ISSUE: Permit to Demolish/Capsulate (partial) and Certificate of Appropriateness for alterations and an addition

LOCATION: Old and Historic Alexandria District
405 South Washington Street

STAFF RECOMMENDATION

Figure 3: 1891 Sanborn Fire Insurance Map showing footprint of buildings along South Washington Street

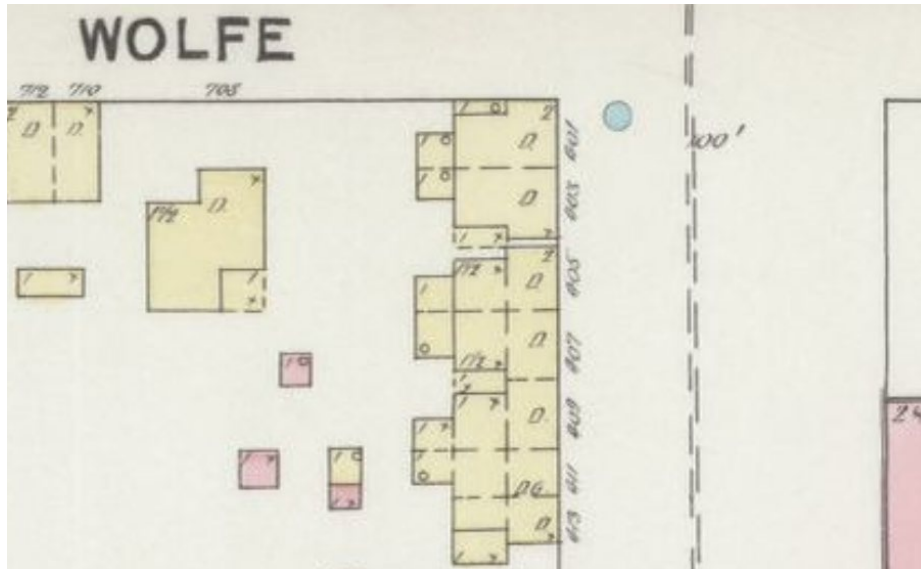
the property. Sanborn Fire Insurance Maps from 1891 show the building with a single story rear portion of the building that is smaller in footprint than the existing configuration (Figure 3). It also shows the main, side gable portion of the building with a wood shingle roof.

Figure 4: Proposed extent of demolition/capsulation

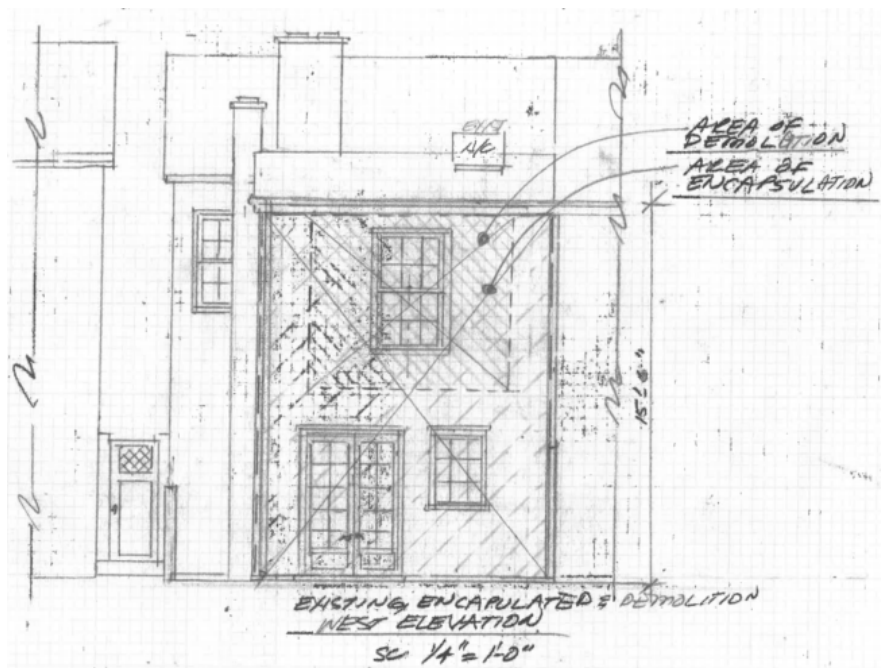
In the opinion of staff, none of the criteria for demolition and capsulation are met and the Permit to Demolish/Capsulate should be granted. As noted above, the portion of the building proposed to be demolished/capsulated dates from the middle 1930s and is not original to the structure (Figure 4). The applicant proposes a very limited amount of demolition/capsulation that is not of unusual or uncommon design and could be reproduced easily.

Figure 5: Proposed west elevation

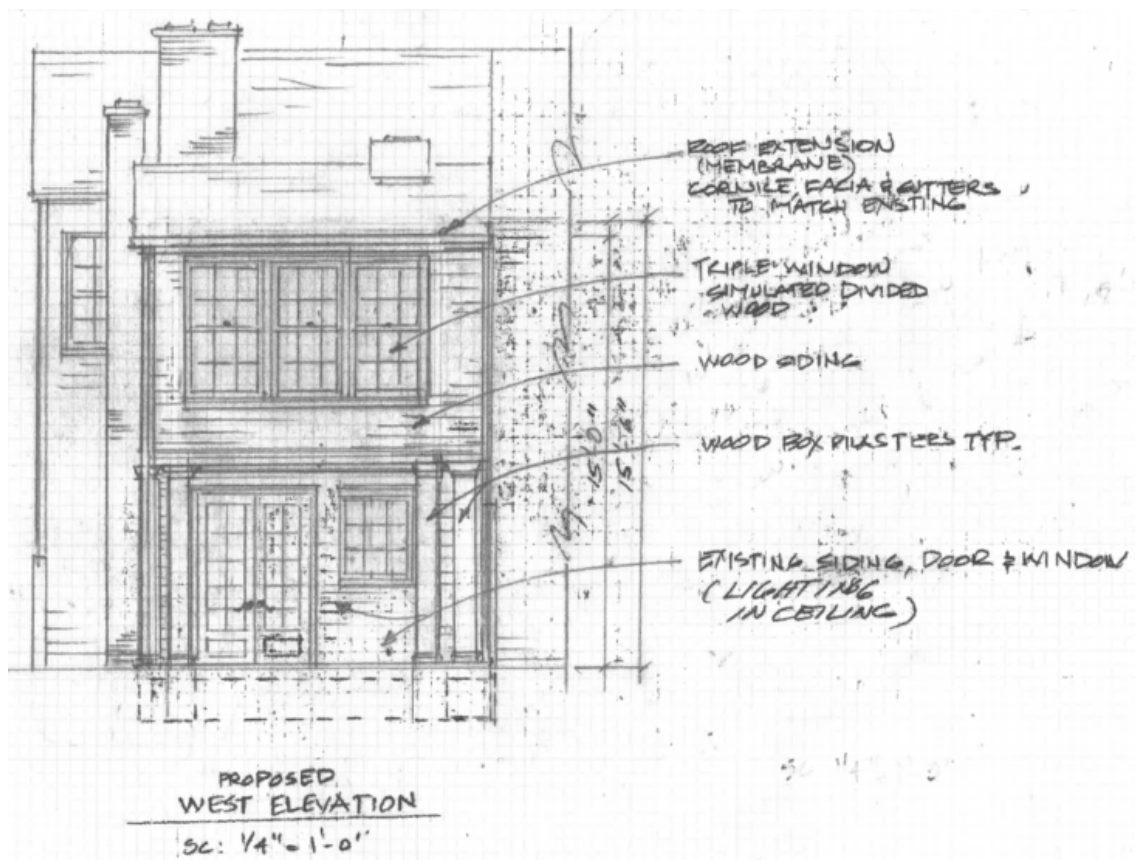
The *Design Guidelines* say that “An addition to a historic building should be clearly distinguishable from the original structure. An addition should not obscure or dilute the architectural and historic importance of an existing building by creating a false sense of the past.” They further state, “The Boards generally prefer addition designs that are respectful of the existing structure and which seek to be background statements...” The proposed addition is limited in size, extending only 5’ from the existing rear elevation and follows the form of the existing building by extending the current roof line. The ground floor of the proposed addition will be a porch that will be covered by the overhanging 2nd floor massing. This open porch will allow for a view of the existing rear of the building, clearly distinguishing it from the original structure (Figure 5).

The proposed addition features square pilasters engaged to wing walls that support the upper mass of the addition. The triple, double hung window at the second floor aligned with the double door and single window on the ground floor presents a well proportioned elevation to the rear of the structure that clearly does not overwhelm the historic building. The use of cementitious siding for the addition will further serve to clearly distinguish this as an addition separate from the existing building.

Staff finds that the proposed addition is consistent with the *Design Guidelines* and the City of Alexandria Zoning Ordinance referencing standards for Washington Street because the design is clearly distinguishable from the original portion of the building while remaining compatible with and similar to other buildings adjacent to Washington Street. Staff recommends approval of the project with the following conditions:

2ND FLOOR FAR STUDY
1/4" = 1'-0"

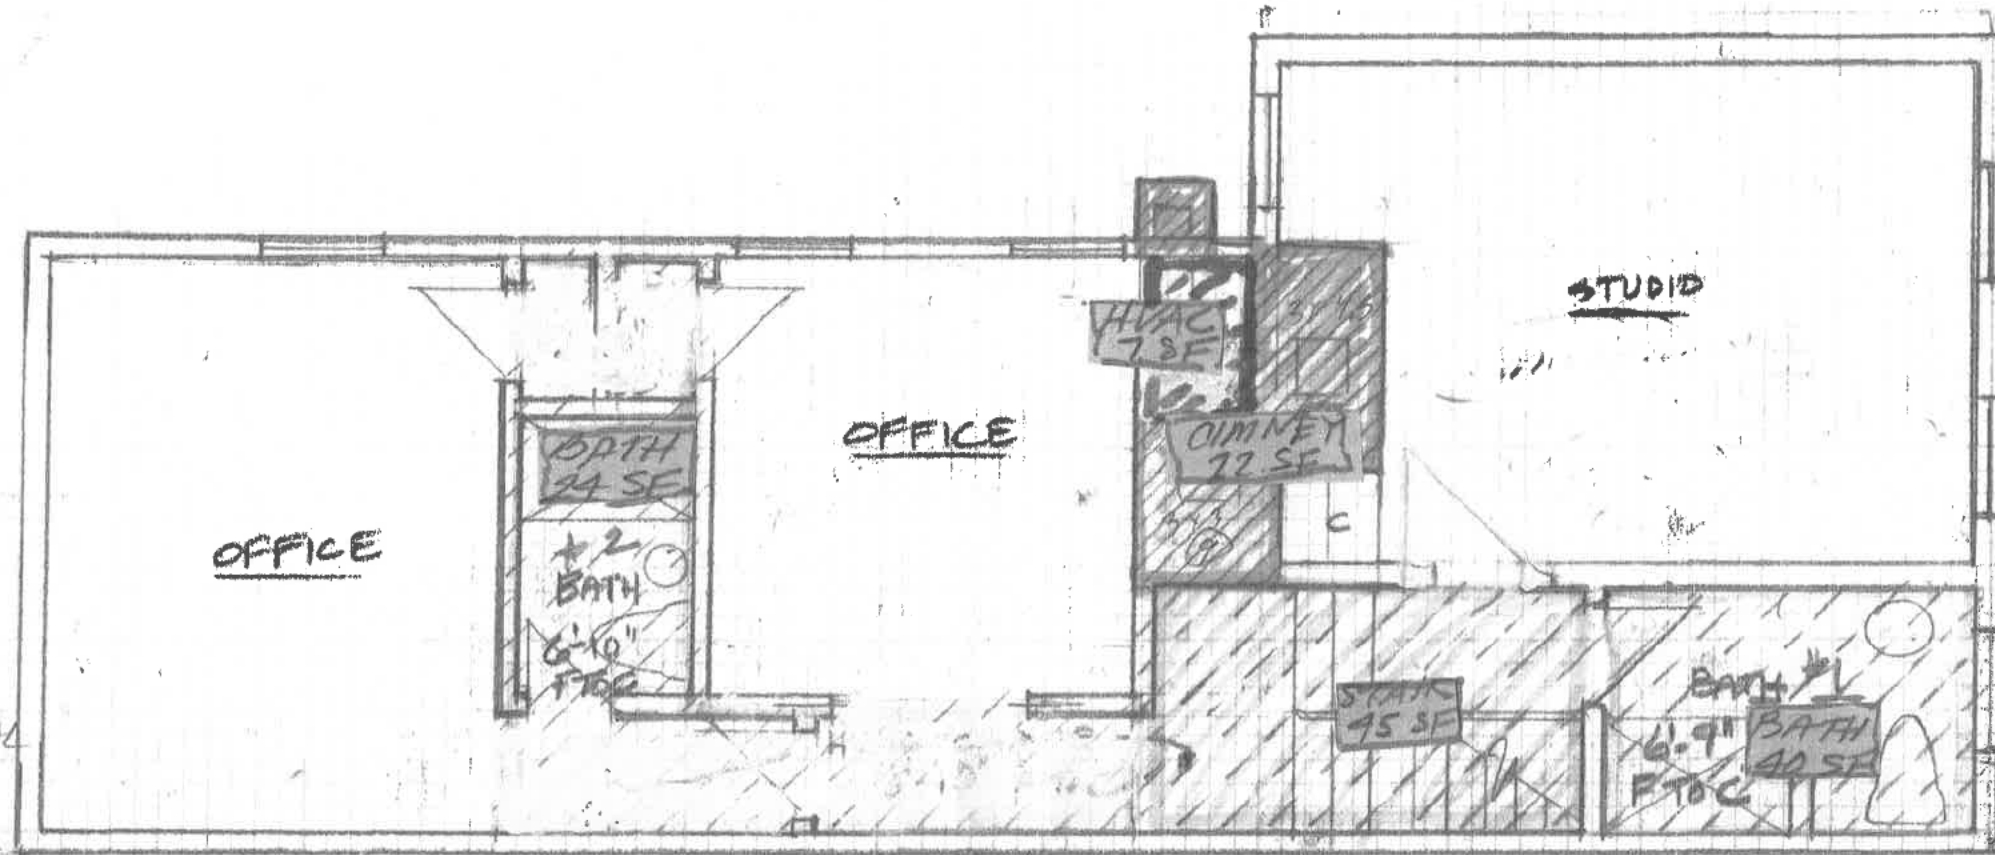
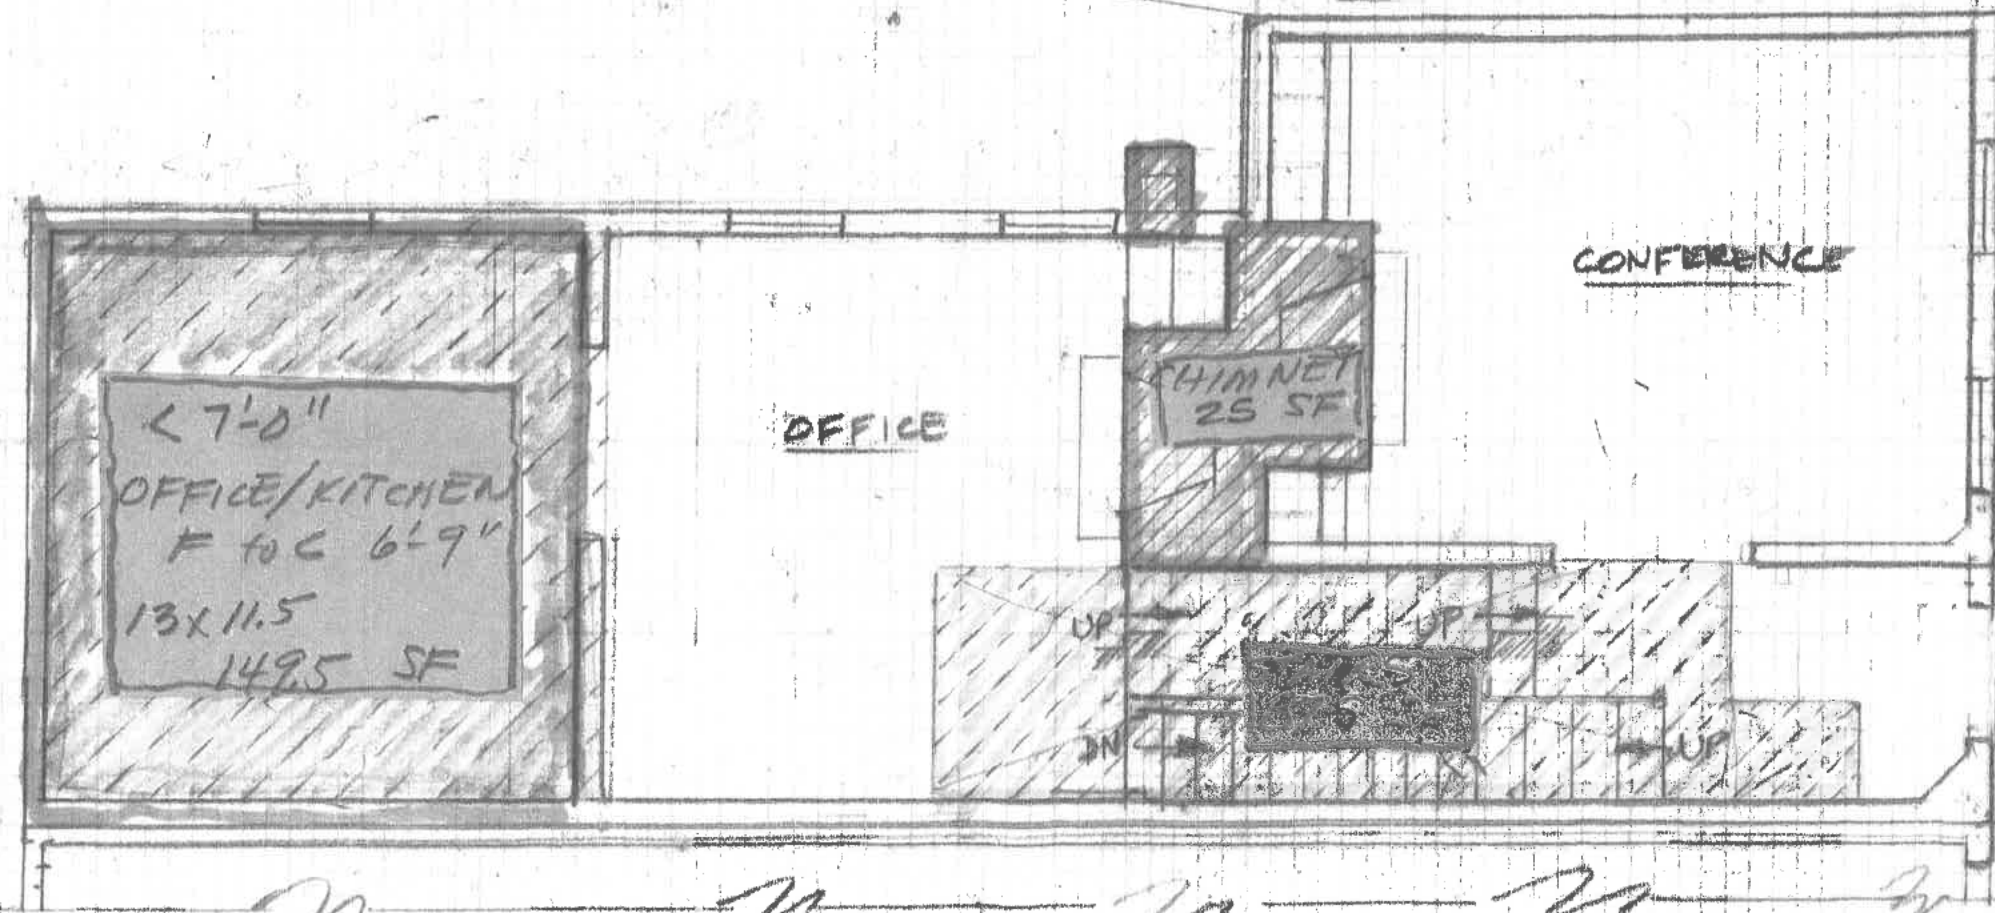
- F-2 The second floor of the proposed rear addition is shown as being under seven feet in height and therefore can be excluded from FAR. Plans showing this ceiling height must be submitted when applying for a building permit.
- F-3 The proposed two-story rear addition complies with zoning.
